Application Number P24-03

P24-03
Acme Final Site Plan and Conditional Sign Permit

Property Owner: Albrecht Incorporated
 Applicant: Greg Ernst
 Location: Northwest Corner of Wooster Pike and High Point Drive (Parcel #028-19C-20-153)
 Zoning: SPD-1 (Special Planning District) with Underlying C-3 (General Commercial)
 Request: Final Site Plan approval for a grocery store with a pharmacy drive through and Conditional Sign approval for Shopping Center signs

**Map From Jansen Wehrley
Director of Parks, Recreation,
Cemetery, and Forestry**

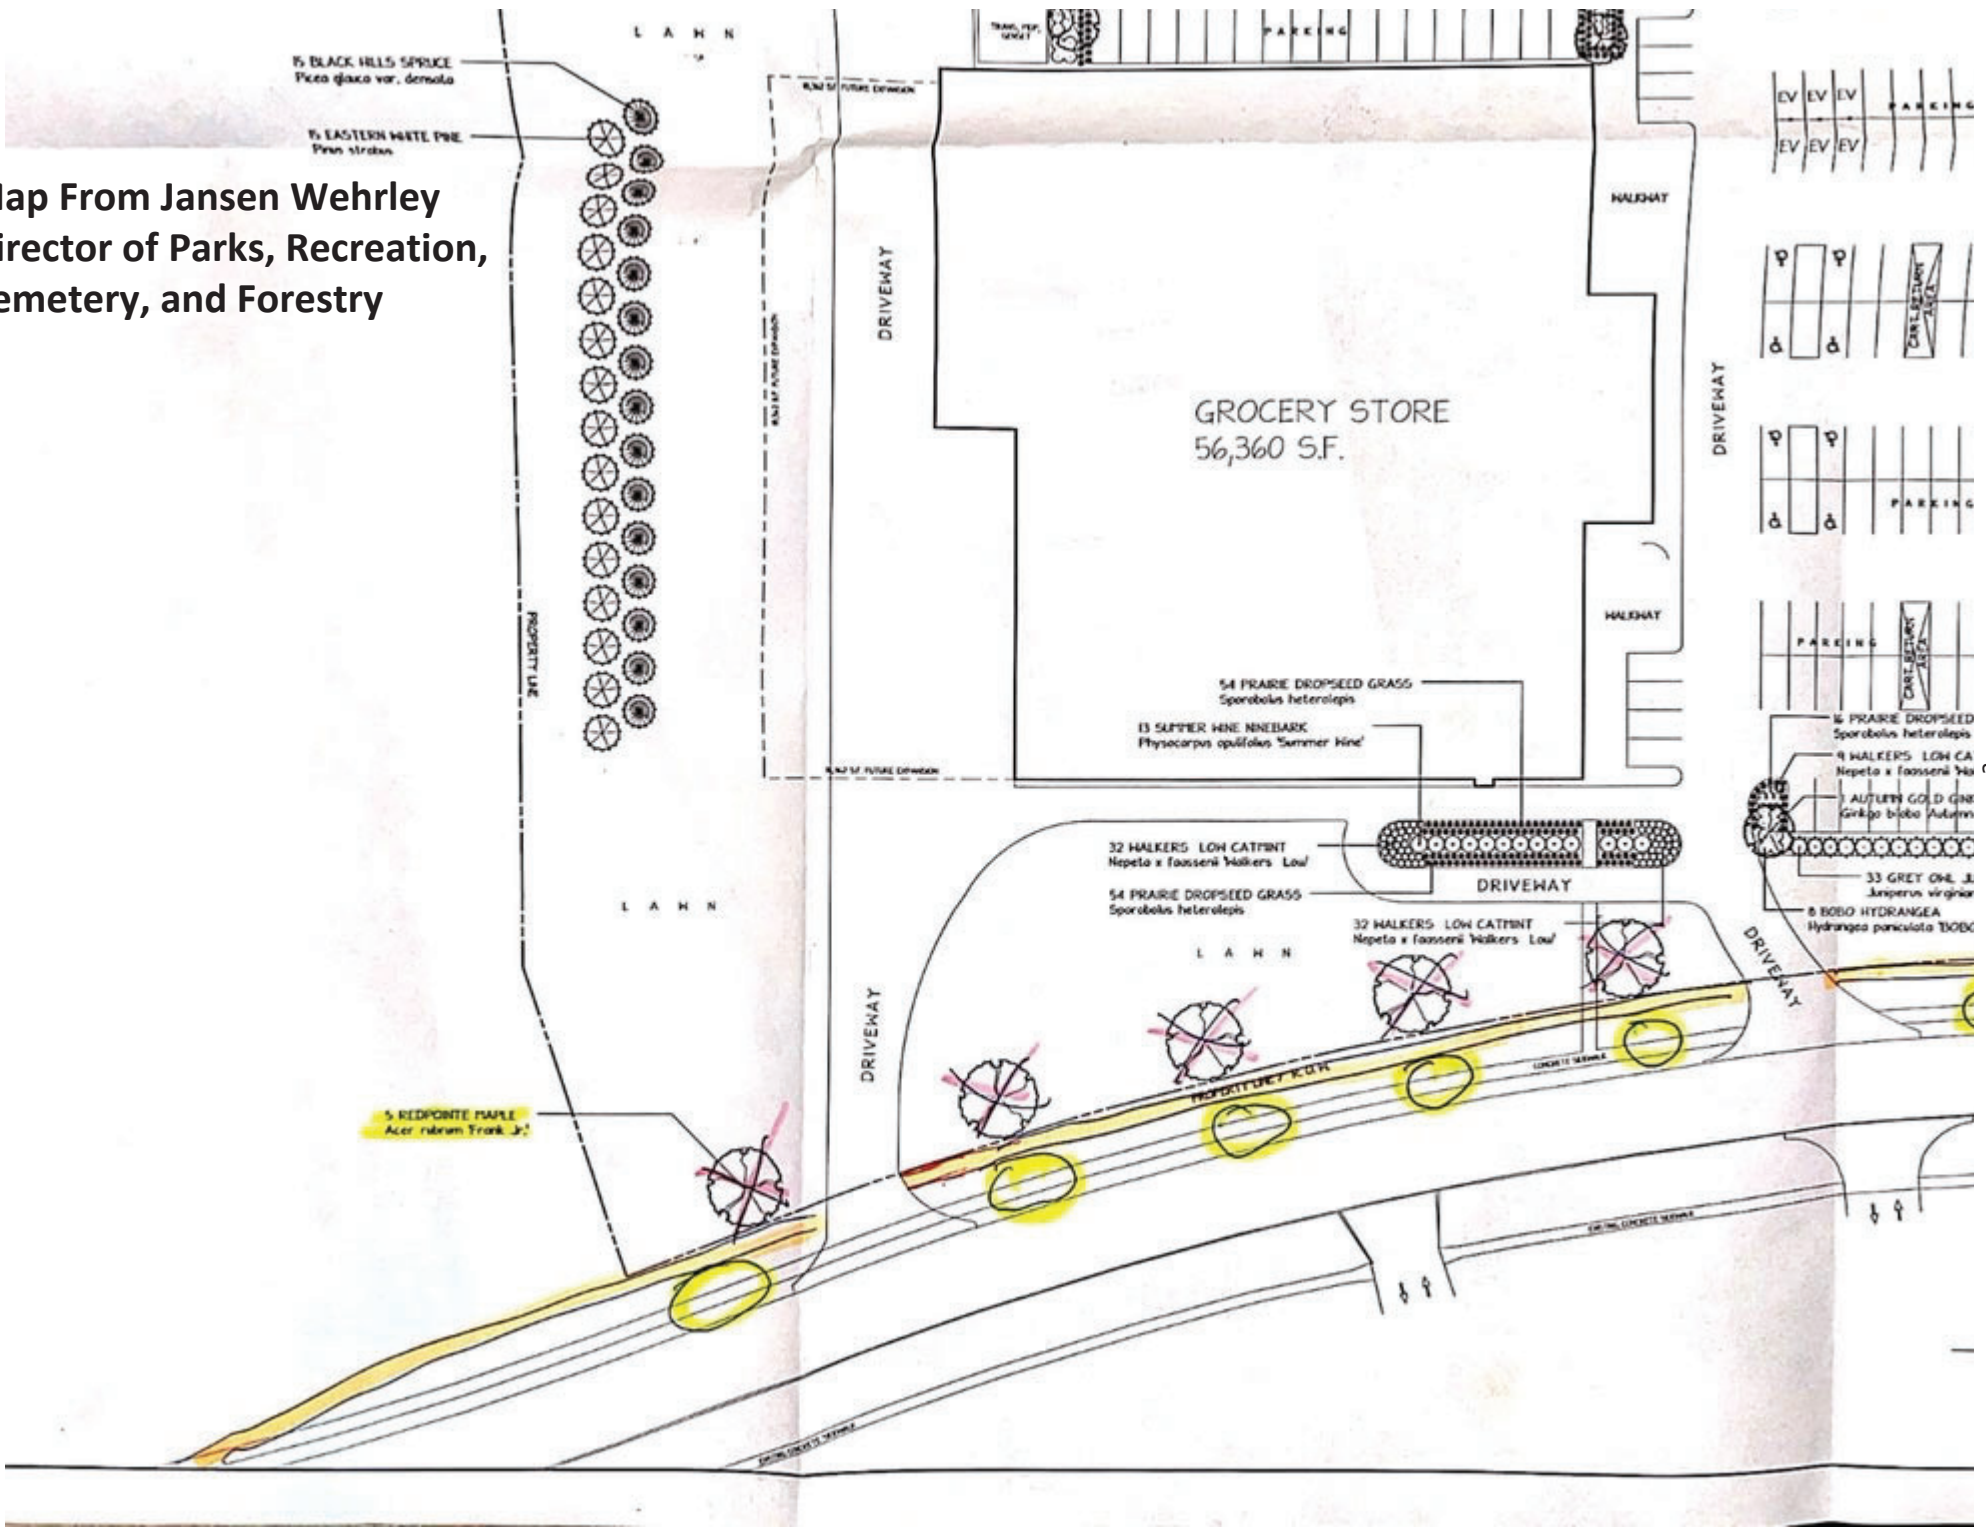
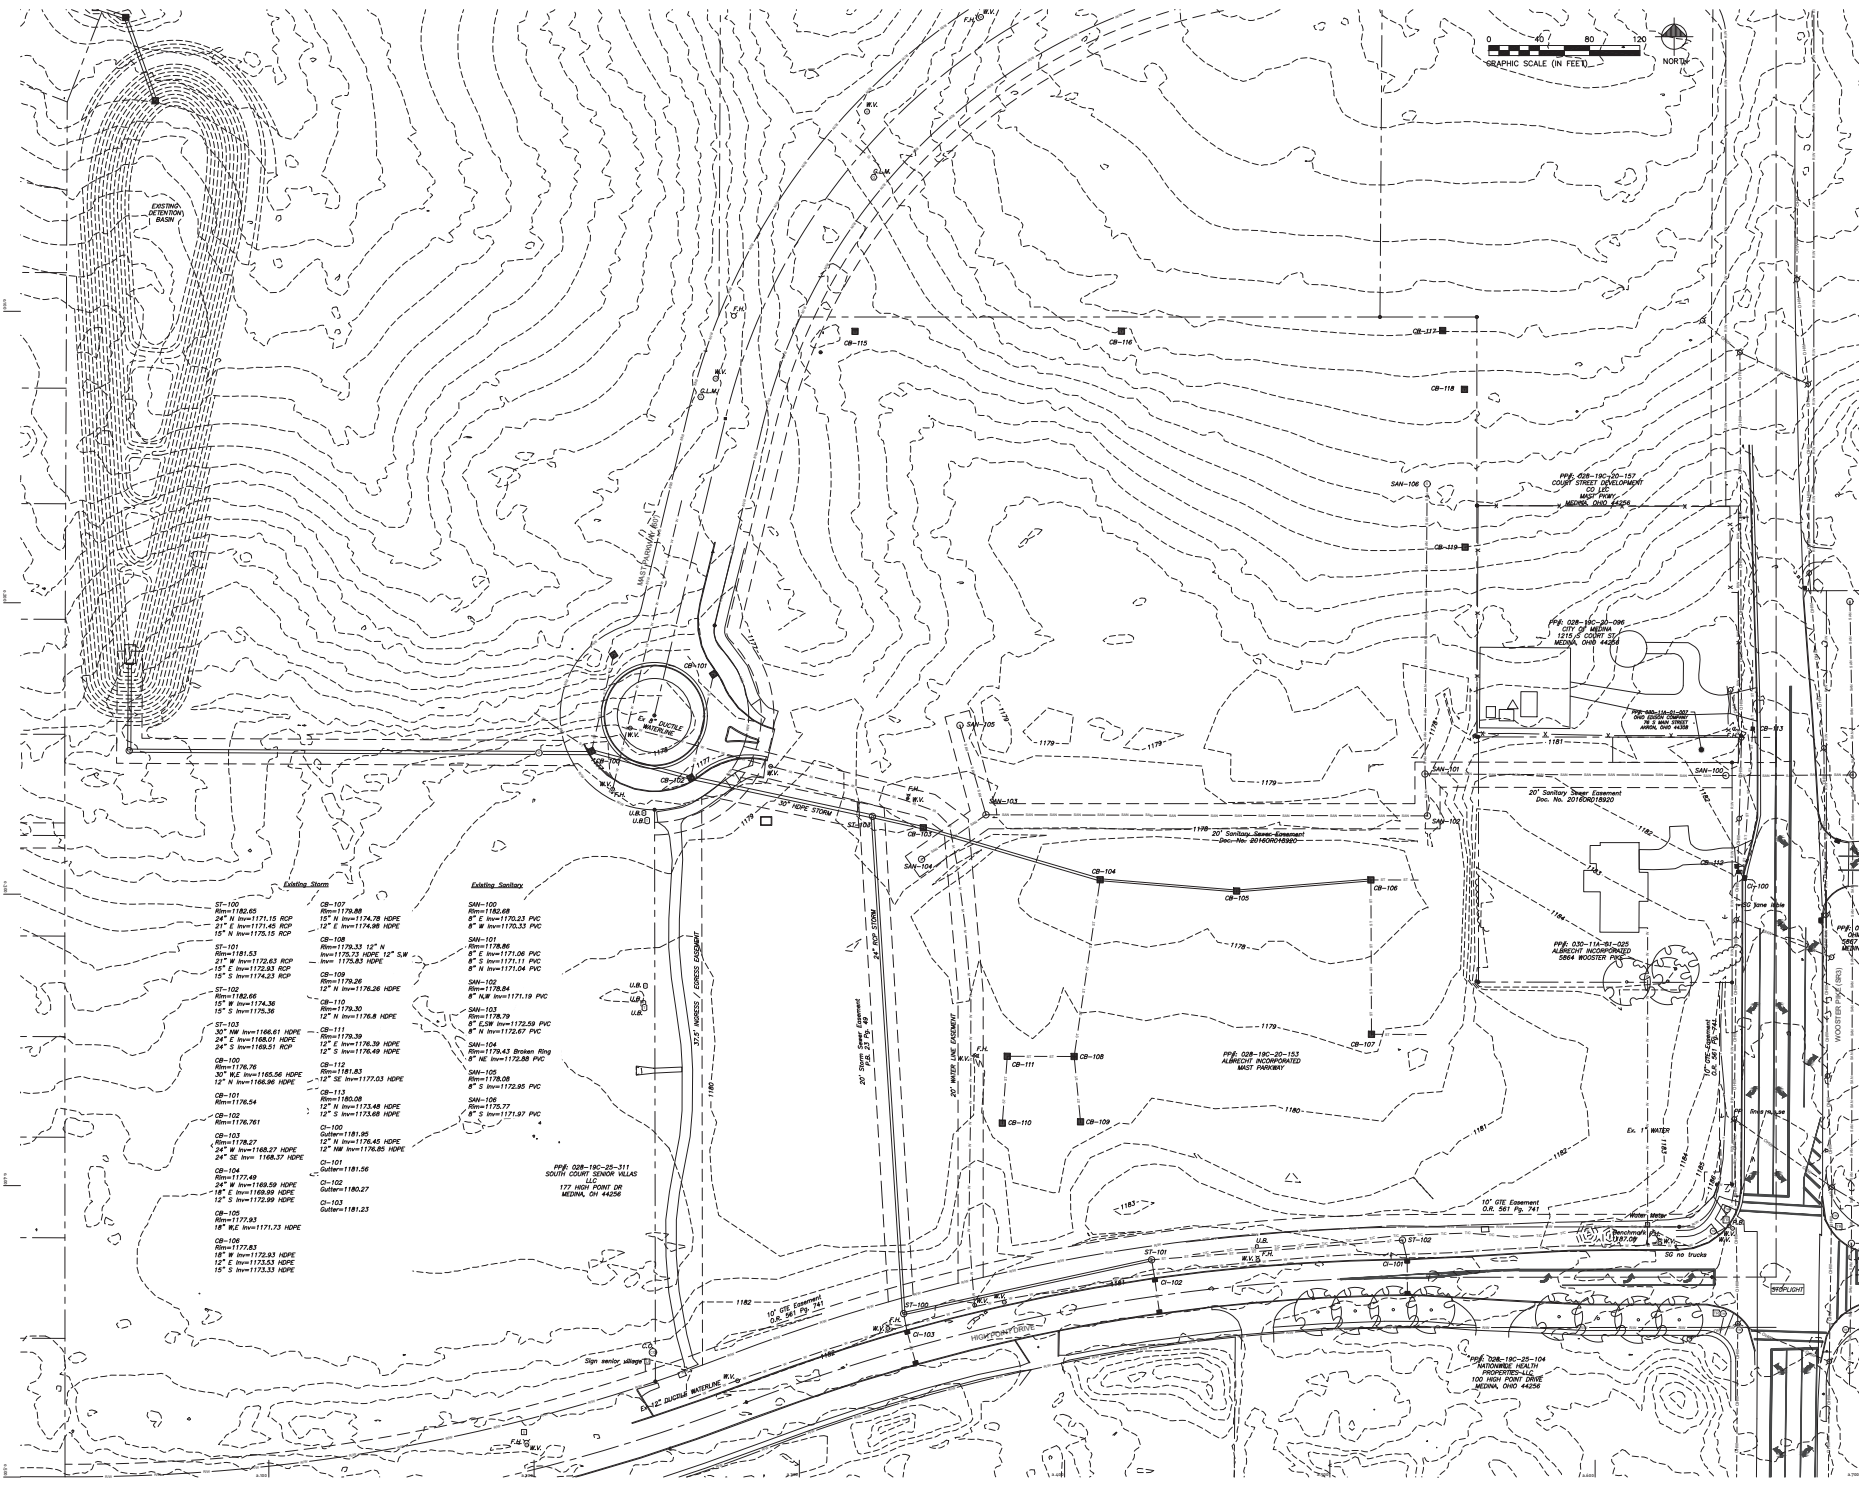
The Forestry Department has communicated to the applicant that seven street trees should be installed along High Point Drive. This request includes two trees located east of the middle drive, however, trees are spaced significantly further apart than 40 ft. Plans have been revised to include street trees as recommended by the Forestry Department.

As per our discussion, the City of Medina Forestry Department does have the power to plant, care for, maintain, remove, and replace trees in the public right-of-way within the City of Medina. For this particular project we made a request in the Staff Report that large canopy street trees be included in the landscaping plan along High Point drive. Spacing could be determined based on entry/exit drives, signs, etc. and that we would like to see approximately 40' spacing between street trees. This request was made so that street trees could be incorporated into the general landscape design for the site.

I had some discussion with our engineering department regarding the ROW and sidewalk placement as indicated on your design. That sidewalk will need to be shifted to the edge of the ROW. As such, I feel it would be appropriate to move the 5 trees you have on the south side of the property into the right-of-way, include two additional trees as indicated on the drawing below, and keep the species as originally recommended. The *Acer rubrum* 'Frank Jr.' is a great performer that is broadly pyramidal reaching a height of 45' and width of 30'.

I think it's really beneficial to include these trees in the landscape design and that we work together so that your client knows exactly what to expect with the final landscape.

SITE PLAN - PHASE 1
SCALE: 1" = 40'-0"
NORTH

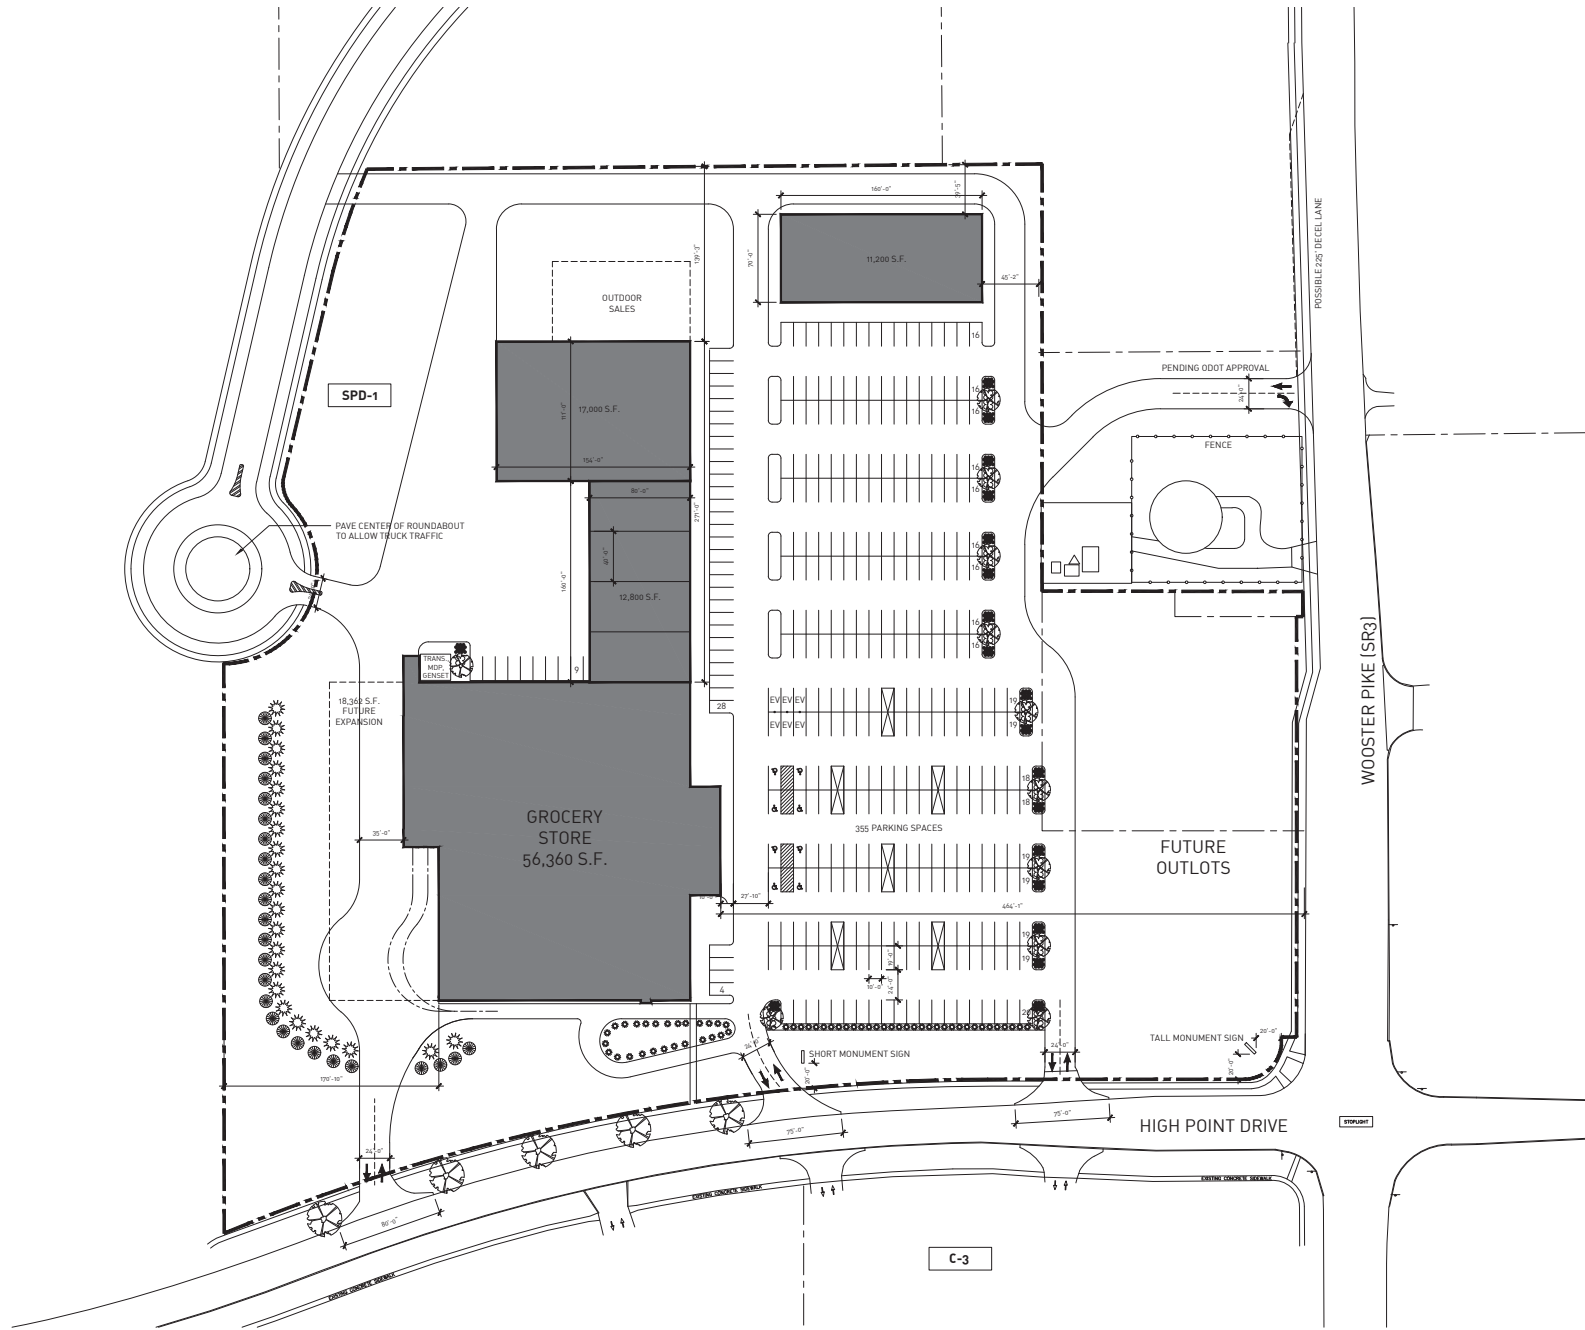
The proposed site incorporates 213 total parking spaces, which exceeds the maximum indicated. However, the proposed parking lot appears to be appropriate for the project. In addition, “Phase 2” of the development will reduce parking on the north side of the grocery store and will result in shared parking between future inline tenants and the grocery store.

1. Please refer to the attached engineering checklist for site plan approval.
2. The site plans included in the application packet shows an access point onto SR 3. Please be aware that the Ohio Department of Transportation (ODOT) has jurisdictional authority of SR 3 at this location. The Developer will have to secure approval from ODOT for that access point. I know ODOT has received and are currently reviewing the Transportation Impact Study for this development. Please be advised that after their review, ODOT may allow an access onto SR 3 as shown on these plans, they may not allow any access onto SR 3, or they may only allow a revised version of the proposed access. In addition, if ODOT does allow for some form of an access onto SR 3, they may require improvements along SR 3 as a condition of that approval (a deceleration lane, for example).

3. The site plan indicates that the drive onto SR 3 will cross a portion of the City's water tower parcel. Please be advised that City Council will have to approve of any improvement onto City property. In addition, the City is reviewing Ohio EPA rules to determine what (if any) the minimum clearance distance is between a public water tower and a driveway. While we are certainly open to considering a driveway in the location shown (crossing into City property), there is further review and additional approvals required before the City can commit to allowing this drive location.

- The SR 3 access point as shown on the current site plan is approved by ODOT. If ODOT does not approve the access point as shown, the site plan should be revised to reflect that, and it should be reconsidered by the Commission.
- The portion of the driveway that crosses the City water tower property is acceptable to the Ohio EPA and receives City Council approval.

Wall Sign Option A

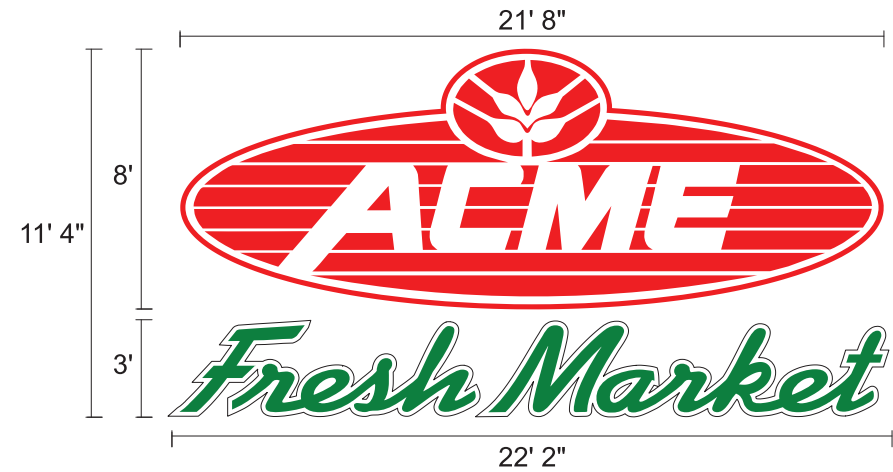
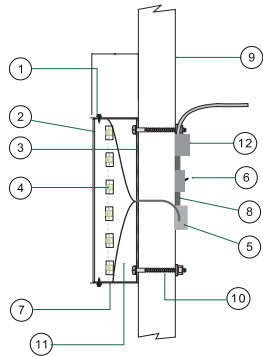
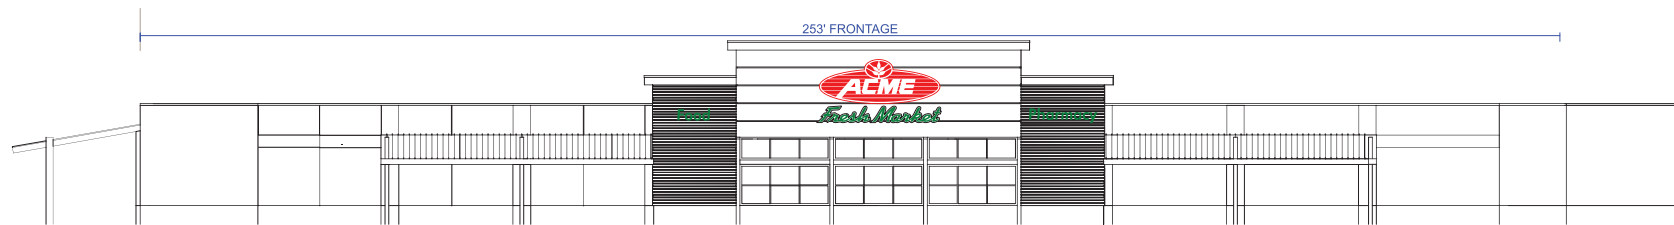
Wall Signs – The building incorporates 3 wall signs on the east elevation and 1 wall sign on the south elevation. Plans show two options for the main “Acme Fresh Market” sign. As outlined below, Option A does not comply with area requirements, while Option B does comply. Per the SPD Development Guidelines, Option B is the only permissible main wall sign.

Wall Sign	Elevation	Option A Area	Option B Area	Area Max.
Acme Fresh Market	East	245 sq. ft.	214 sq. ft.	-
Pharmacy	East	24 sq. ft.	24 sq. ft.	-
Food	East	12 sq. ft.	12 sq. ft.	-
Total East	East	281 sq. ft.	250 sq. ft.	253 sq. ft.
Pharmacy Drive Thru	South	28.5 sq. ft.		57 sq. ft.

- (4) Wall signs on the east building elevation shall not exceed 253 sq. ft. in area and the electronic message center portion of the Development Sign shall be removed or the South Court Village SPD-1 Guidelines shall be further amended by City Council to allow an electronic message center portion of the Development Sign.
